**CITY OF LOUISVILLE  
STARK COUNTY, OHIO**

**METZGER PARK BASEBALL & SOFTBALL FIELDS**

**ADDENDUM #1**

**THRASHER PROJECT #101-T30-11111**

1. AFTER EXCAVATION OF EXISTING SOIL TO THE PROPER ELEVATIONS REQUIRED THE NEW SUBGRADE WILL BE SHAPED AND COMPACTED TO 95% DENSITY WITH A 0.5% SLOPE TO ALLOW FOR DRAINAGE.

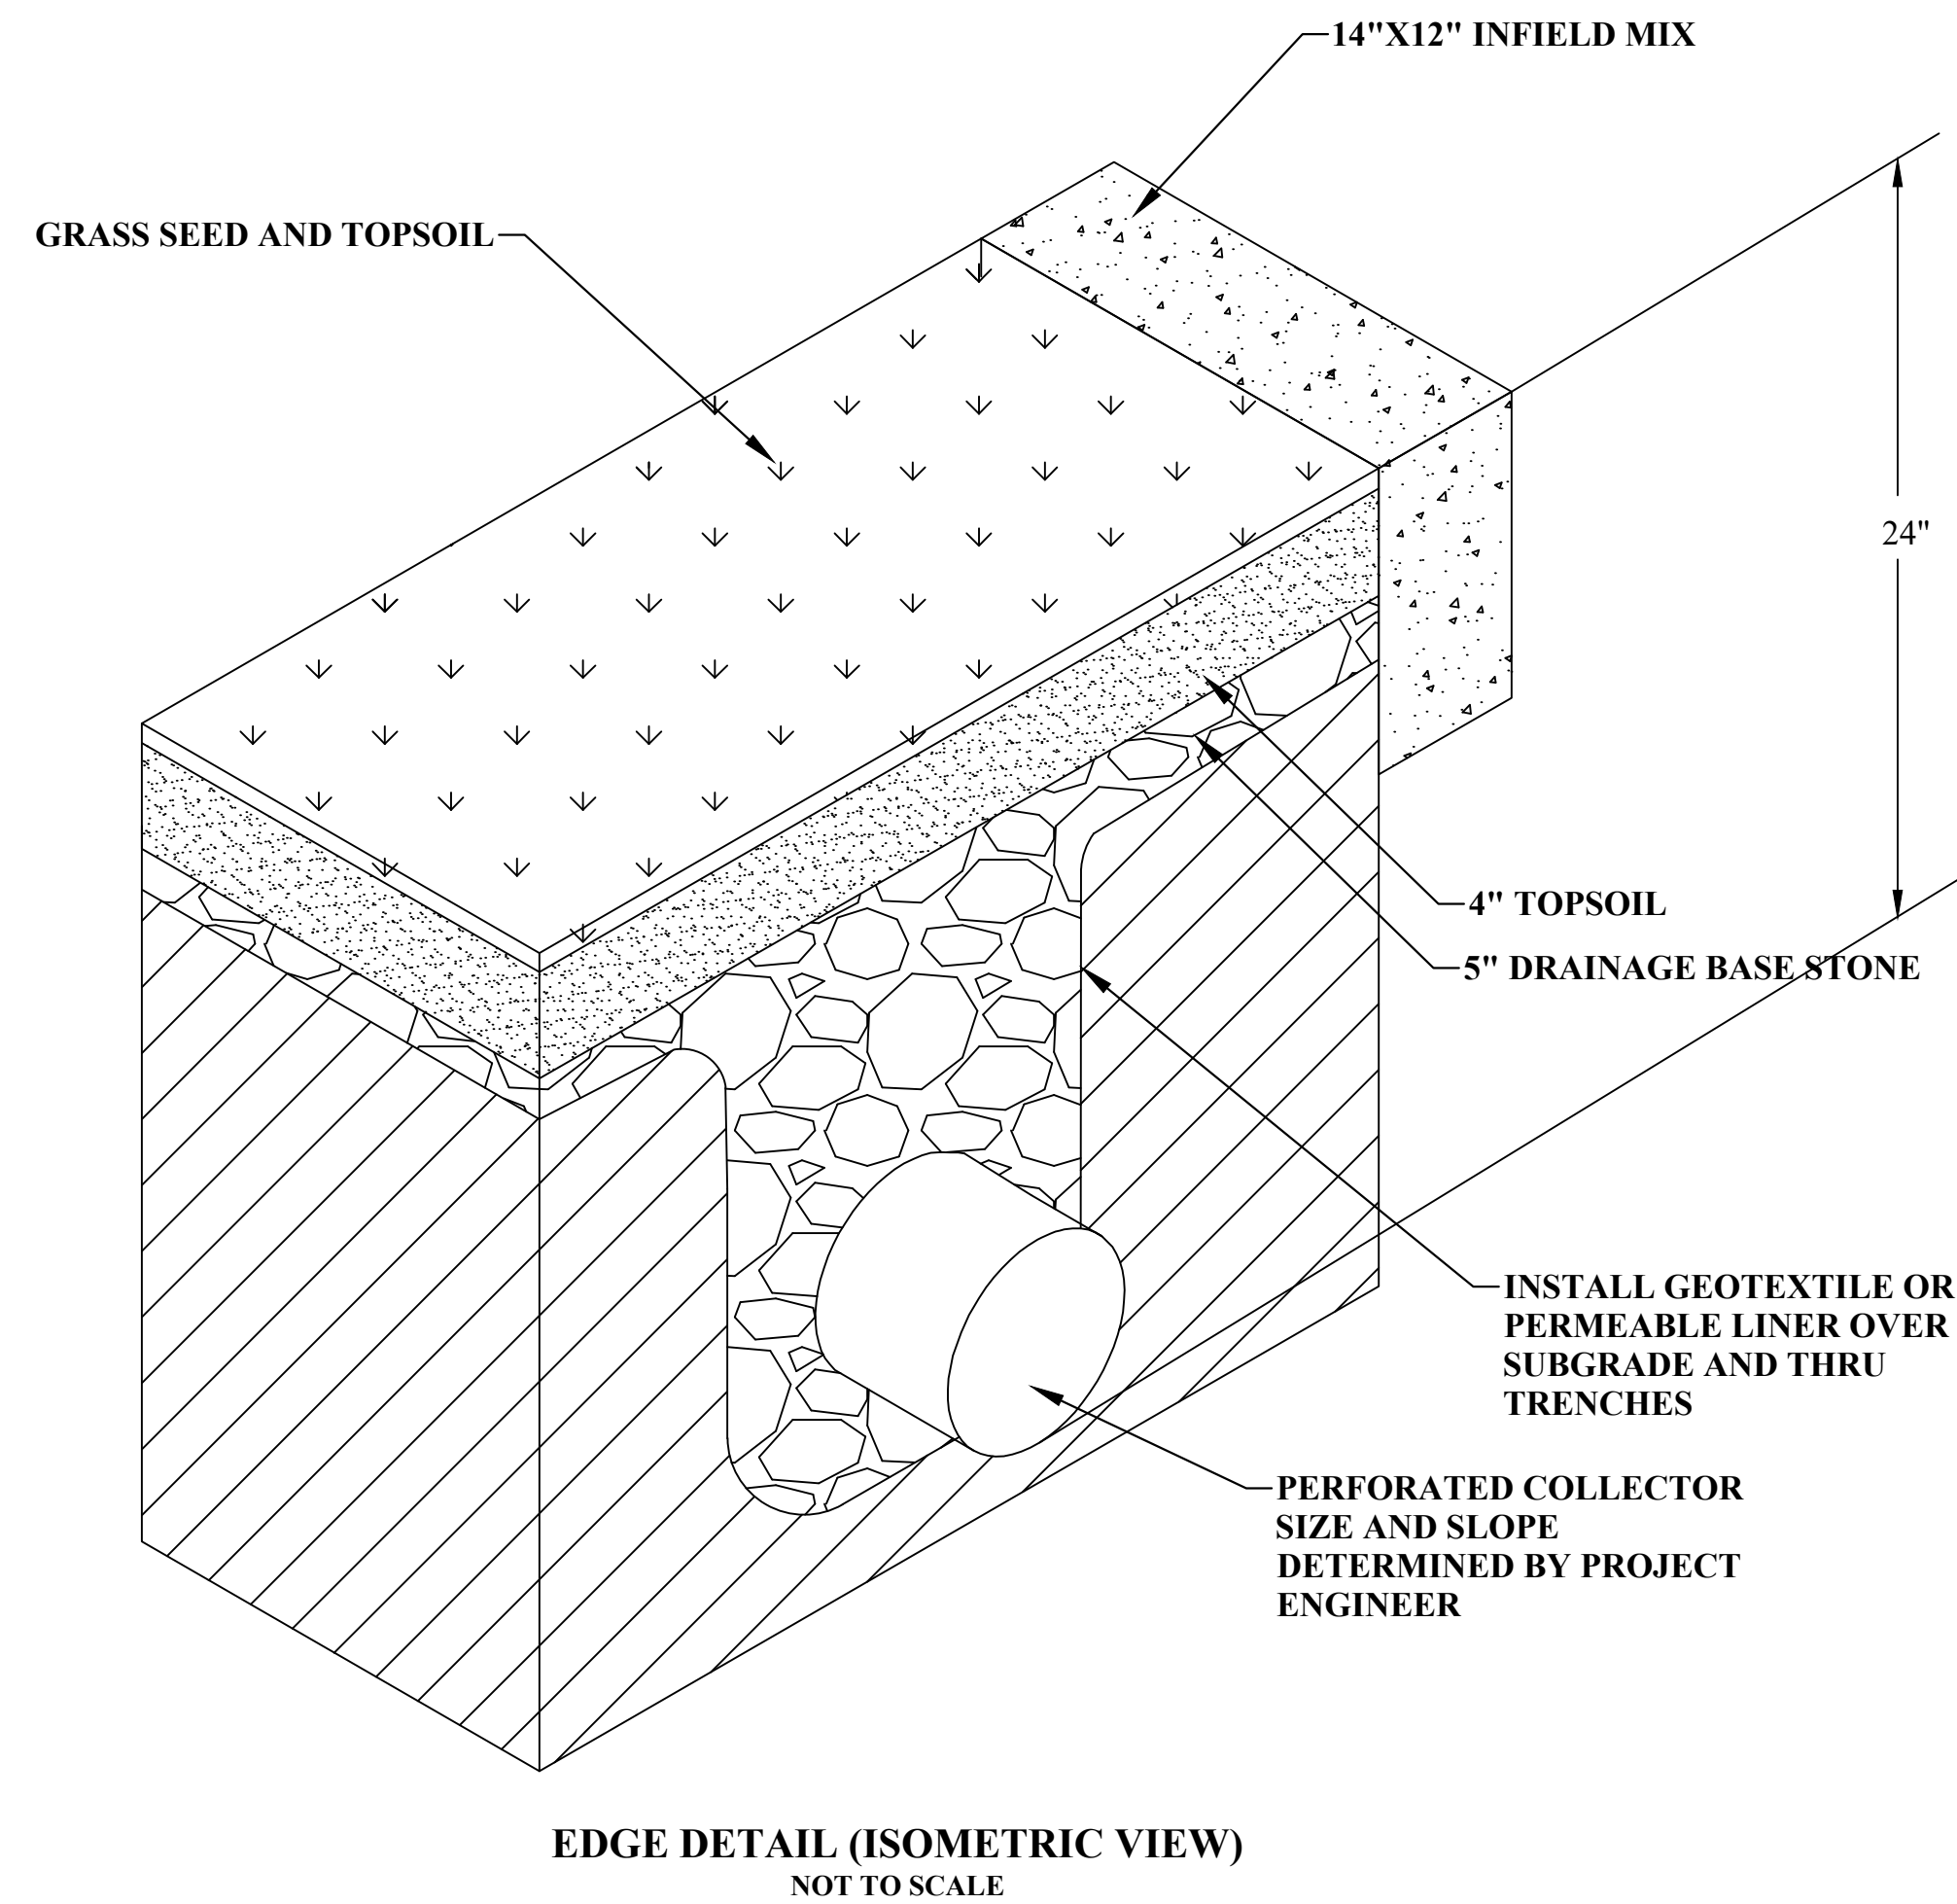
- a. Referencing the "EDGE DETAIL (isometric view)" 14"x12" Infield mix - with the FIELD DRAINAGE NOTES: #2 "A NEW CONCRETE CURB AND NAILER WILL BE INSTALLED AROUND THE PERIMETER TO PROVIDE A SECURE EDGE TO STOP FIELD MIX MIGRATION" There is no allocation on the BID SCHEDULE. Is this item to be considered a non-perform item?

- b. Referencing the "EDGE DETAIL"(both views) It Appears that the geotextile fabric would extend to encompass the entire subgrade of the infield only. If that is the case, can an itemized quantity per field be provided? As well as a specific fabric?

**The outer edges of the infield mix have no concrete curb. Updates have been made to field drainage note number 2.**

**The geotextile fabric has been provided in the Bid schedule.**

2. NAILER WILL BE INSTALLED AROUND THE PERIMETER TO PROVIDE A SECURE EDGE TO STOP FIELD MIX MIGRATION. IN ALL CASES THE NAILER AND STONE ARE AT THE SAME ELEVATION.
